22 July 2021

C92266

Letter of Addendum (refer to AIA Xavier C92266) – Design proposal/methodology Trees 301 and 321

Figure 1. Excerpt from retaining wall detail (PS124859-20210719). (Client, July 2021).

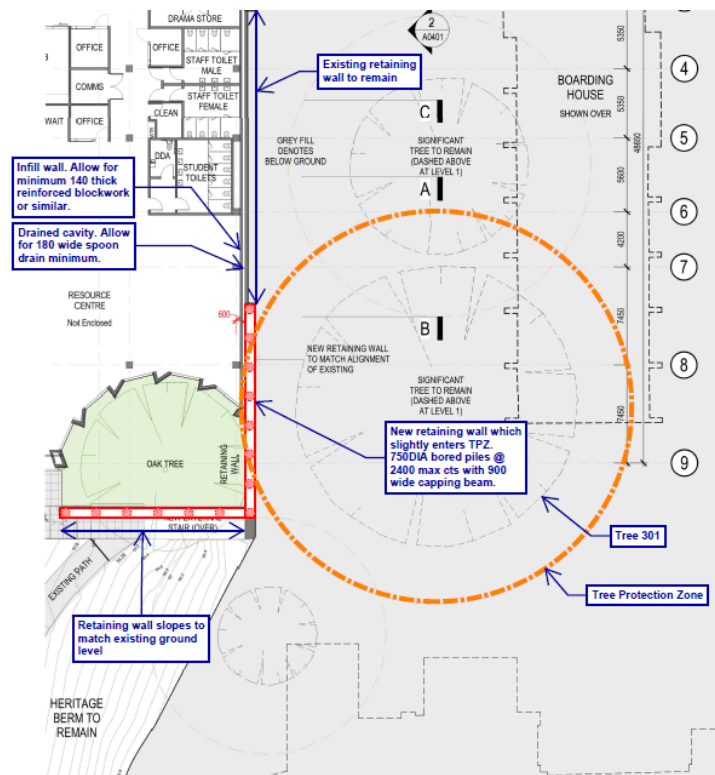
Figure 1 is an excerpt from the retaining wall detail plan which shows the construction of a new retaining wall to the west of Tree 301. In keeping with root sensitive design, the wall is to be constructed using piles so as to avoid the need for slot trenching/excavation.

Where additional generic tree protection controls are observed (refer to AIA), retaining wall installation (as per the supplied plans) would not be considered detrimental to the post project viability of Tree 301. Any variation to this proposal will need to be reviewed by the project arborist in advance of works.

Figure 2. Excerpt from general arrangement plan (A0251 HV2). (Client, July 2021).

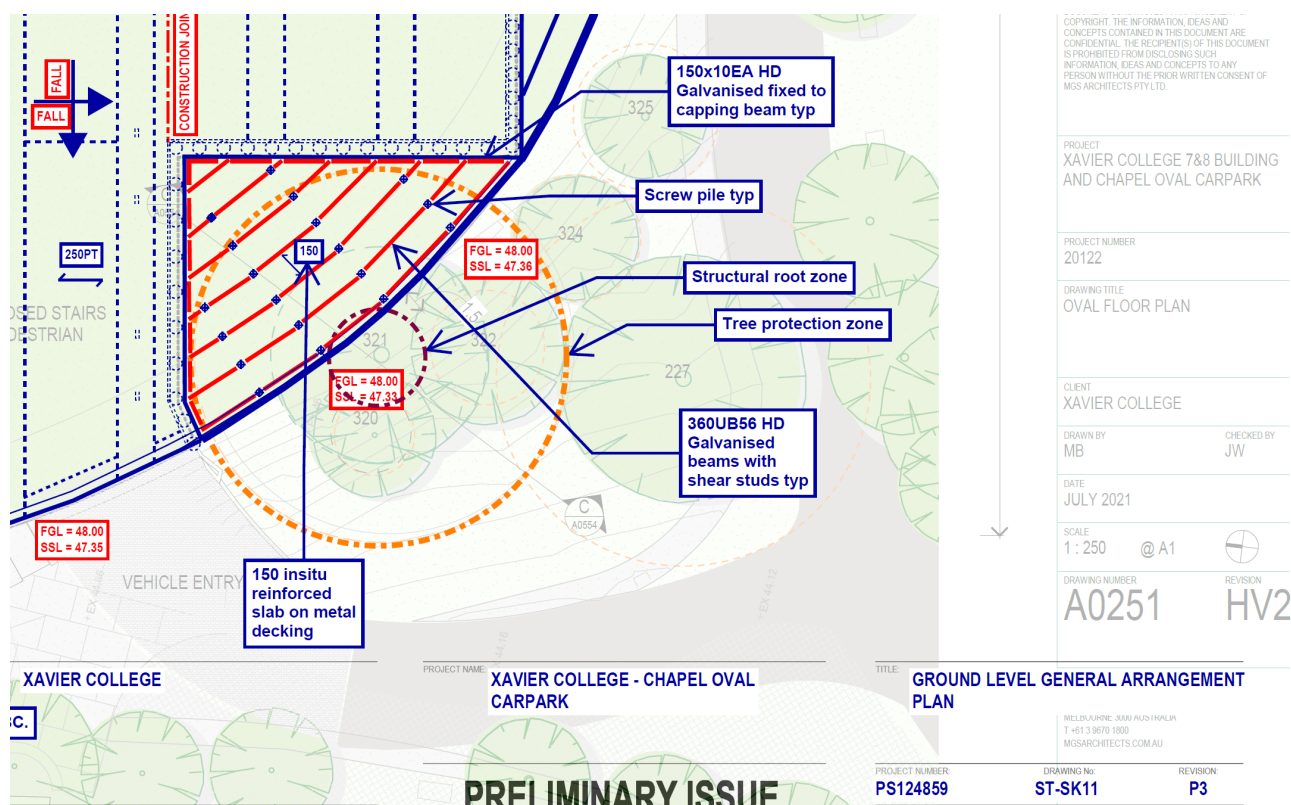
Figure 2 is an excerpt from the general arrangement (ground level) plan which shows the construction of a suspended slab to north-east of Tree 321. In keeping with root sensitive design, the slab is to be constructed using a reinforced slab over metal decking (galvanised pier and beam) so as to avoid the need for slot trenching/excavation.

It is recommended that mulching (seasoned tree mulch or similar) be installed to a depth of 75mm extending to the edge of the TPZ (where practicable) and that an irrigation/reticulation system be installed (by a competent person) within the area to be covered by the suspended slab. Aftercare periods, irrigation frequencies and volumes, and additional plant health care (PHC) measures are to be determined by the project arborist post (slab) installation.

Where PHC measures (i.e. mulching and irrigation), the supervision of pier placement (by the project arborist) and additional generic tree protection controls (refer to AIA) are observed, suspended slab installation (as per the supplied plans) would not be considered detrimental to the post project viability of Tree 321. Any variation to this proposal will need to be reviewed by the project arborist in advance of works.
